PETITION FOR VARIANCE APPLICATION

Name of Owner <u>JSM Properties LLC</u>	Project Description <u>Porch reconstruction in the Historic Mansion Hill neighborhood.</u>	Agent, architect, or engineering firm <u>Westring Construction LLC</u>
Company (if applies)		No. & Street <u>4617 Novelsail Dr. Ste 8</u>
No. & Street <u>110 N. Mills St</u>	Tenant name (if any)	City, State, Zip Code <u>Madison, WI 53704</u>
City, State, Zip Code <u>Madison, WI 53715</u>	Building Address <u>315 N. Pinckney St.</u>	Phone <u>(608) 441-5435</u>
Phone <u>(608) 255-3933</u>	Madison, WI. 53703	Name of Contact Person <u>James Westring</u>
e-mail		e-mail <u>james@westringconstruction.com</u>

City Required Ancillary Hand Rail

3. illustration

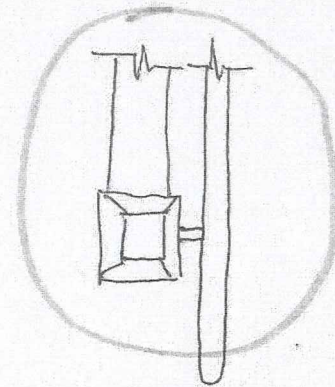
- The rule being petitioned cannot be entirely satisfied because:
It would alter the appearance of a historically restored property. The rail requirements also cannot be met @ the top portion primarily because there is no surface to turn the rail into w/o having to alter the railing.

- Add Ancillary grab (wood) .
protruding in to the
stair area

Using a non-skid additive to the paint on the treads or
installing non-slip coarse, adhesive backed tape to edge of treads

* Adding a simple 1 1/4" to 1 1/2" diameter handrail (wood & painted) to match in a simple fashion.
Using a bright color, such as traffic yellow (?) on the leading edge of the treads.
